LINCOLN/LANCASTER COUNTY PLANNING STAFF REPORT

P.A.S.: Stone Bridge Creek
Annexation #00003
Change of Zone # 3265
Special Permit # 1845
Preliminary Plat #00017
Use Permit # 139

DATE: July 3, 2001

Use Permit
STONE BRIDGE CREEK
SITE/ UTILITY PLAN

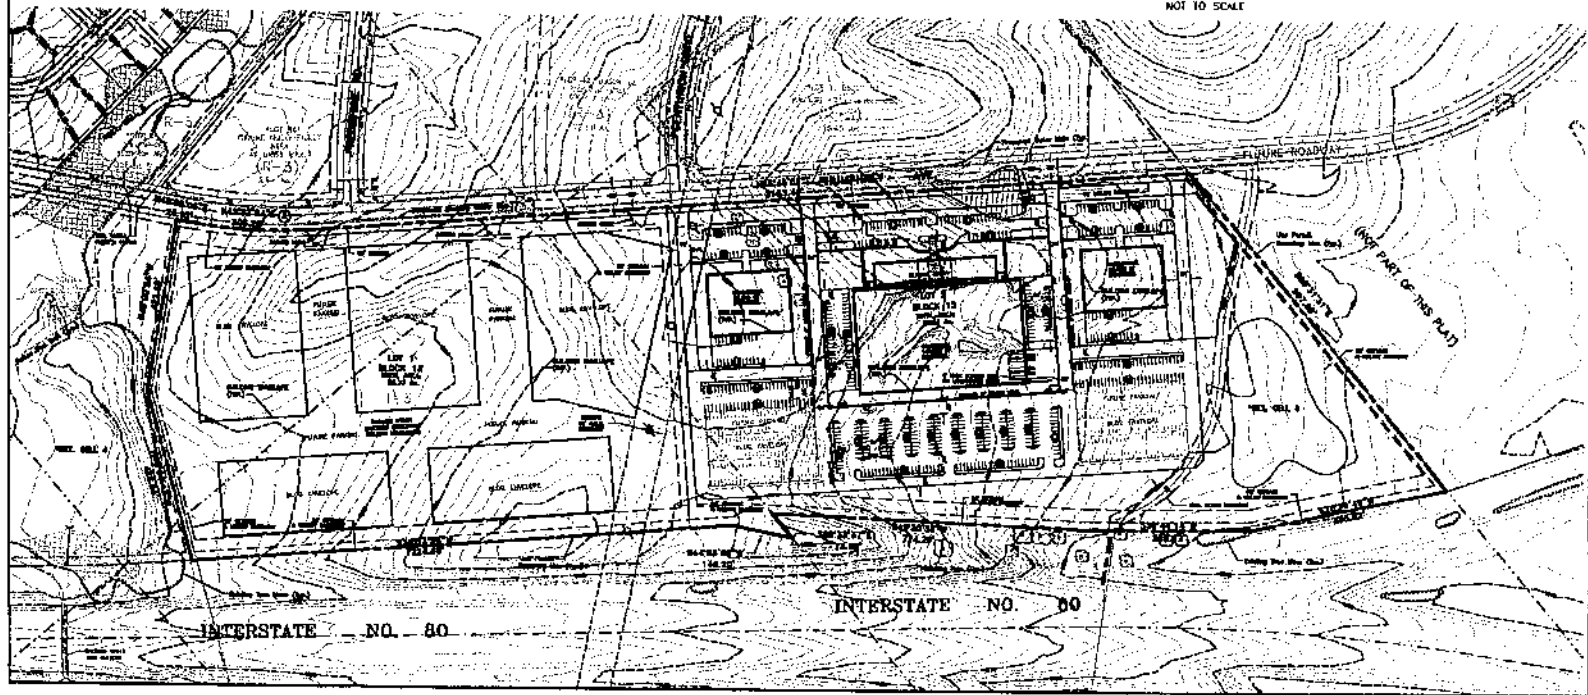
- 1.1 Revise the site plan to show:
 - 1.1.1 The land use parking table to show the same amount of office and industrial square feet as shown on the site plan.

- 1.1.2 Combined notes on sheets 1 and 2 to only one page, the same sheet as the site plan.
 - 1.1.3 Note 12 to read "buildings may be constructed anywhere within the building envelope shown."

- 1.1.4 A landscape plan that removes the street trees from the area of the driveways along Humphrey Ave.
 - 1.1.5 Austrian Pines replaced with a different evergreen species due to serious Pine Tip blight Disease problems.

- 1.1.7 A landscape plan that designates the street tree "Red Sunset Maple" along Humphrey Avenue and planted 40' to 50' on center. No trees

should be planted within 15' of either side of the driveways, street lights and from the street intersections.

- 1.1.8 An easement along the south side of Humphrey for a trail to the satisfaction of the Parks and Recreation Department.
- 1.1.9 Note 20 to indicate that signs will be in conformance with chapter 27.69 and to indicate that building materials will contain no more than 70% metal siding in conformance with 2751.030(b)(6).

- 1.1.10 Guidelines for industrial uses and a 300' setback between the residential districts and the closest industrial building as required by the Study Area Plan adopted by Comprehensive Plan Amendment #94-40.

- 1.1.11 A landscape plan with screening trees with a 30' spread.
- 1.1.12 Plans signed and sealed by a licensed surveyor.
- 1.1.13 A Planning Commission approval block to City Council approval block.

- 1.1.14 Revise the trees in the LES transmission easement to the satisfaction of the Parks and Recreation Department and LES.
- 1.1.15 Add a note to the landscape plan that no plant material shall be planted in the utility/pedestrian easements unless approved by LES or the City.
